Architect's Supplemental Instructions

Architect's ASI No: 048

Project:
Webster University
Interdisciplinary Science
Building

Date Issued: 01/27/2017

2 LEVEL 02 - AREA B - WORKROOM
1/4" = 1'-0"

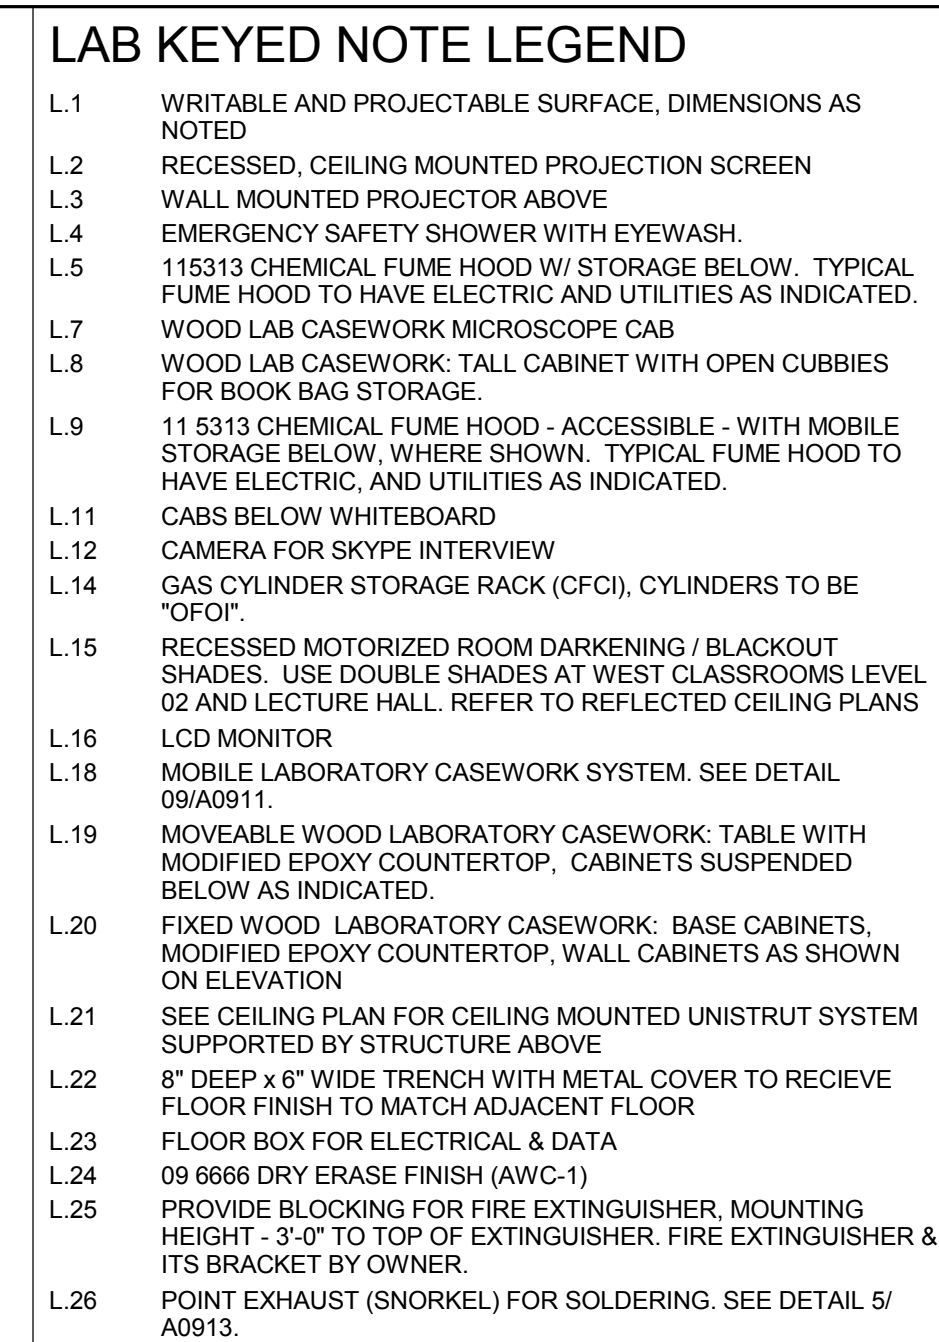
- Room 289B – Casework & equipment location revised.

1 LEVEL 01 - AREA A - FLOOR PLAN - POWER AND AUXILIARY
1/8" = 1'-0"

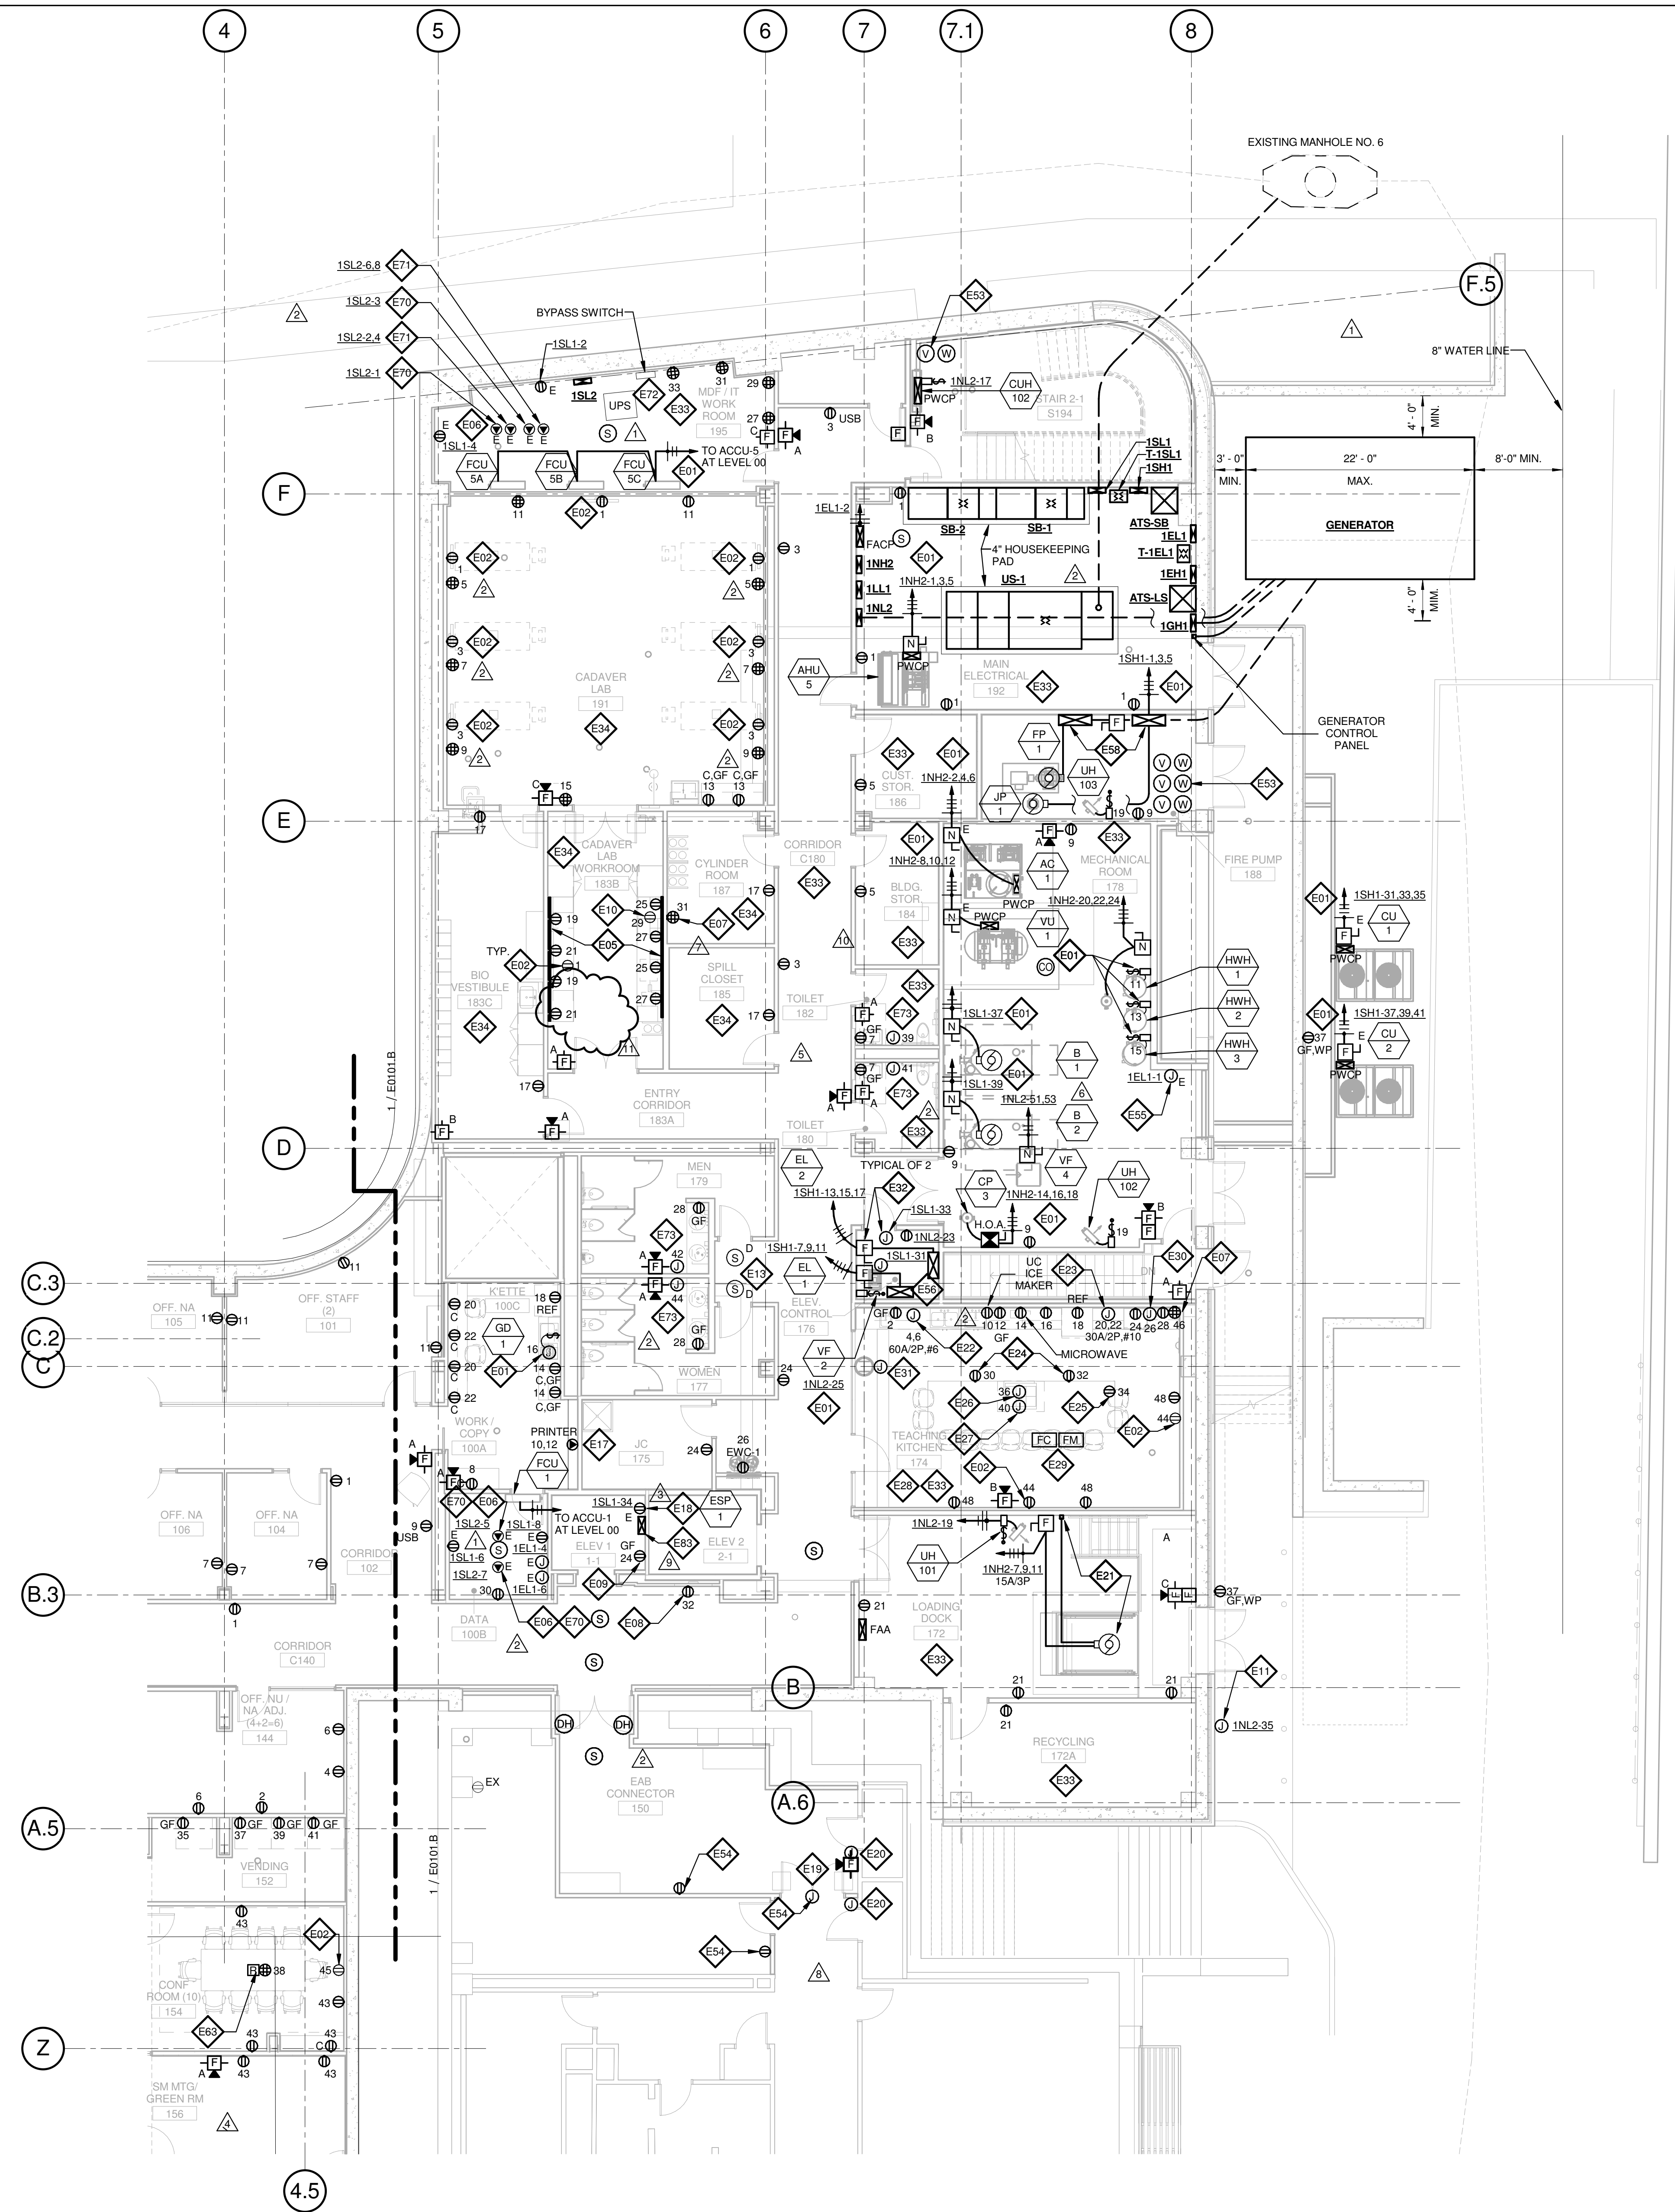
- In Cadaver Lab Workroom 183B, delete Keyed Note E07 and associated quadruplex receptacle and circuit serving AV rack.

E0101.B

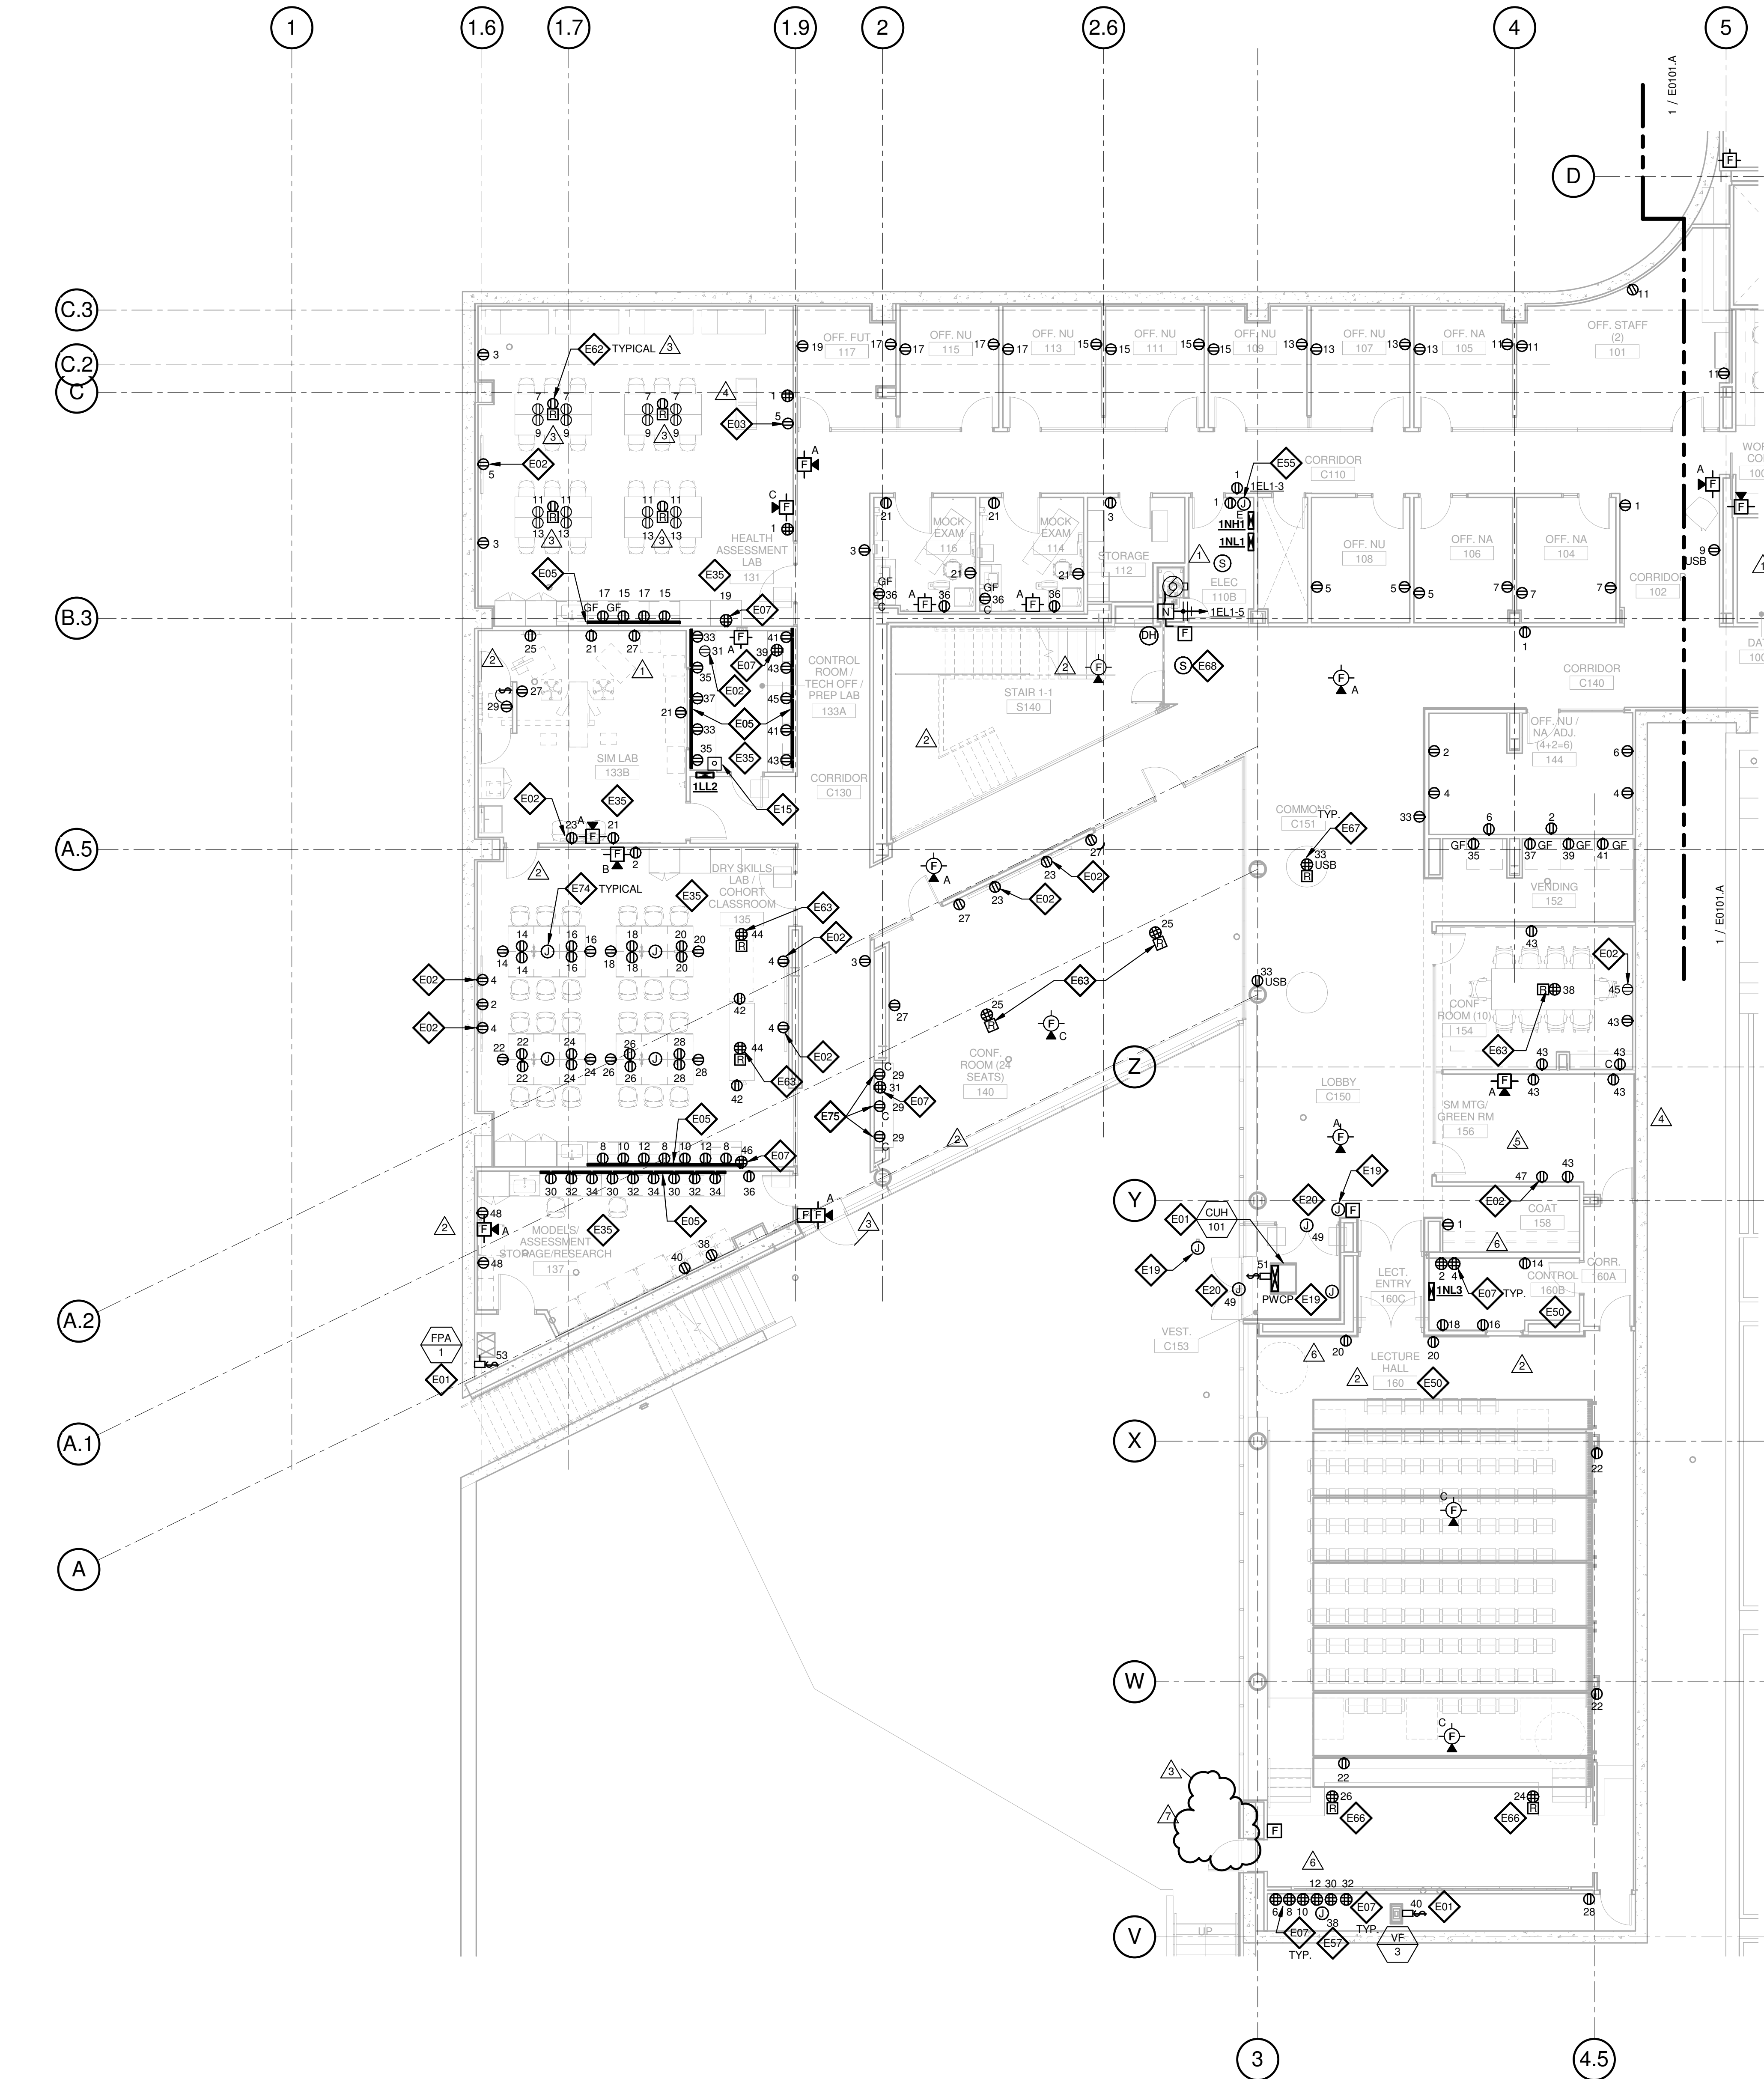
- In courtyard, delete power and final connection to wall mounted emergency intercom station and associated Keyed Note E11.
